Providence City Plan Commission

AGENDA ITEM 2 ■ 31 DIKE STREET

OVERVIEW

Front Elevation, Rendering and Sixth Floor plan

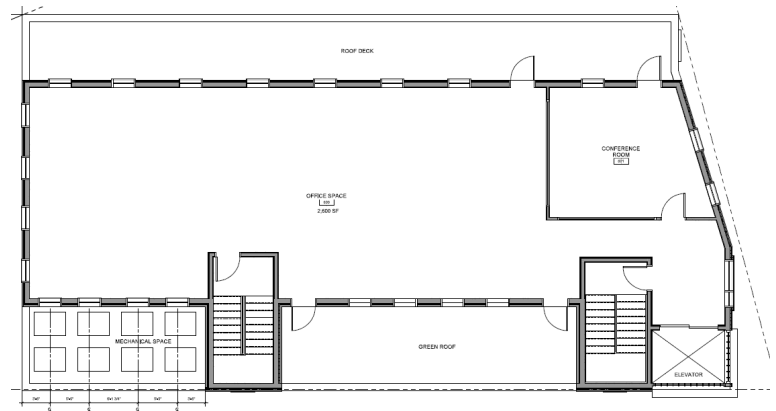
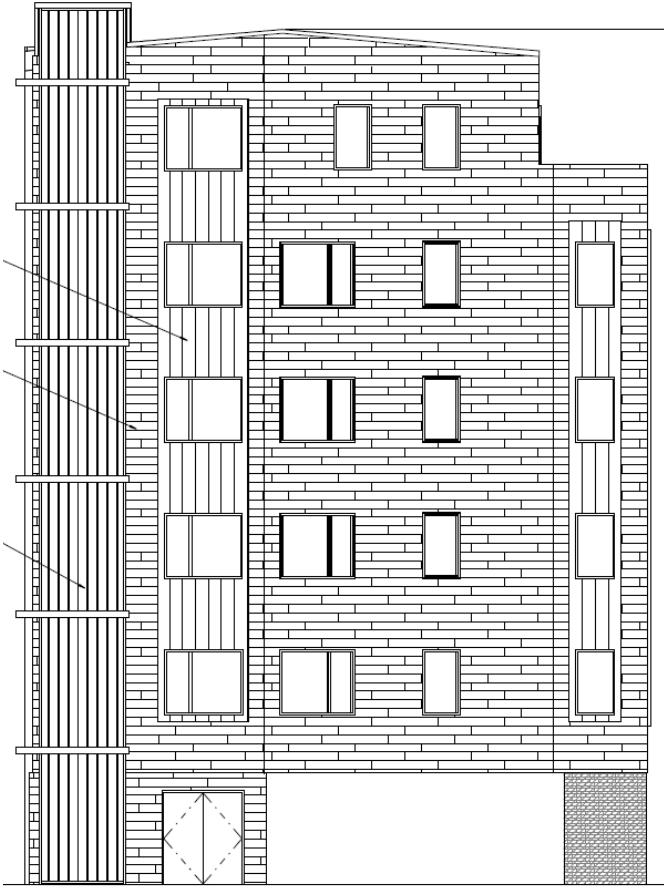
The design of this proposed residential building is contemporary in character but is overly complicated and lacks a strong, cohesive architectural expression. The combination of multiple materials, colors, window patterns, and projecting vertical elements creates a busy façade with competing features.

The prominent corner element is particularly strong and appears slightly disconnected from the main building mass. The orange metal cladding, polycarbonate, and cement-board cladding contribute to a somewhat fragmented appearance. The termination of the vertical orange cladding at the ground level also appears unresolved. There's no architectural transition or connection to the ground-floor façade, which makes it feel applied rather than integrated.

The ground-floor treatment is also relatively utilitarian and should have a stronger relationship to the street and pedestrian environment. Screening of the ground-floor garage opening is recommended to reduce its visual prominence from the street. The proposed knee wall appears as somewhat of an afterthought and should be more integrated into the overall ground-floor design.

The main residential entrance on Dike Street requires greater architectural emphasis so that it is clearly identifiable as the primary entrance to the building. Consideration should be given to a canopy or entry feature, lighting, or building address to announce the entrance.

The proposed rain garden along Dike Street appears to be constructed on the right-of-way (sidewalk).

Staff recommends simplifying the design with a more restrained material palette, clearer façade organization, and better integration of the corner element and ground-floor treatment. A more cohesive design would better respond to the surrounding context.

Dimension and design: The development will comply with the dimensional and design requirements of the C-2 zone subject to the CPC granting the design waiver from the front yard build-to zone requirement and the dimensional adjustment for height. The design at the preliminary plan stage shall incorporate the suggestions from the staff design review.

- The design at the preliminary plan stage shall reflect the suggestions from the staff design review.
- The applicant shall apply for a minor subdivision to layout the lot as shown on the plan.
